UNITED STATES PATENT AND TRADEMARK OFFICE

APPLICATION NO.	FILING DATE	FIRST NAMED INVENTOR	ATTORNEY DOCKET NO.	CONFIRMATION NO.
10/707,273	12/02/2003	Anders Larsson	07589.0081.NPUS01	1272
28694	7590	03/08/2006	EXAMINER	
NOVAK DRUCE & QUIGG, LLP 1300 EYE STREET NW 400 EAST TOWER WASHINGTON, DC 20005			EDGAR, RICHARD A	
			ART UNIT	PAPER NUMBER
			3745

Office Action Summary	Application No.		Applicant(s)	
	10/707,273		LARSSON, ANDERS	
	Examiner		Art Unit	
	Richard Edgar		3745

Figure 1

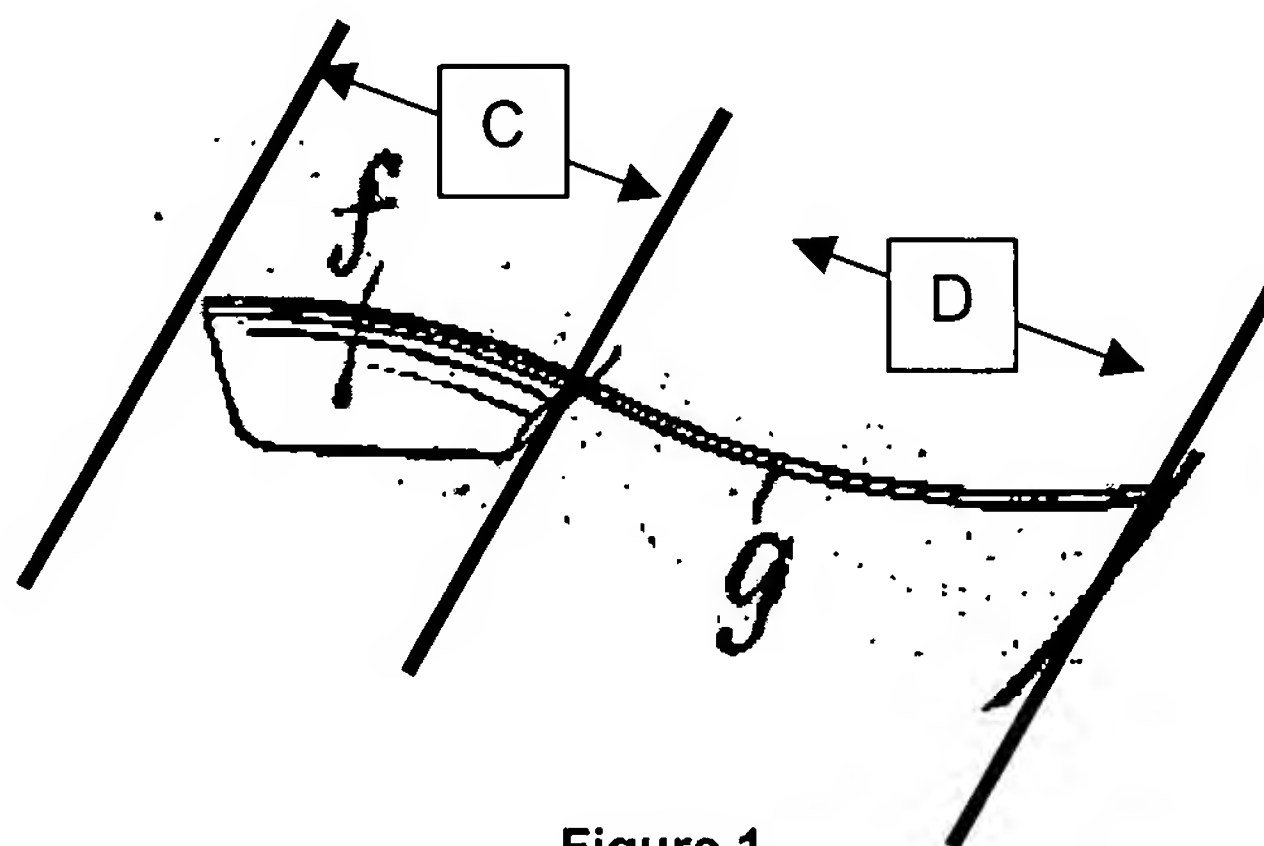
Capell shows a closed-type centrifugal impeller having in Fig. 3 (right-side embodiment) blades *g* extending in the radial direction wherein the radially inner portion of the blade is concave in the direction of rotation and the radially outer portion of the blade is convex in the direction of rotation. As seen in Fig. 3 (right-side) the blade *g* extends to the periphery of the impeller. As can be seen from Figure 1 below, the radially inner curved portion (C) is shorter than the radially outer curved portion (D). The length of C is between 10-40% the length of C+D. The impeller is of a closed-type with a central opening (see Figs.). Capell teaches that the blades may be inclined forward (see page 1, lines 77-80).
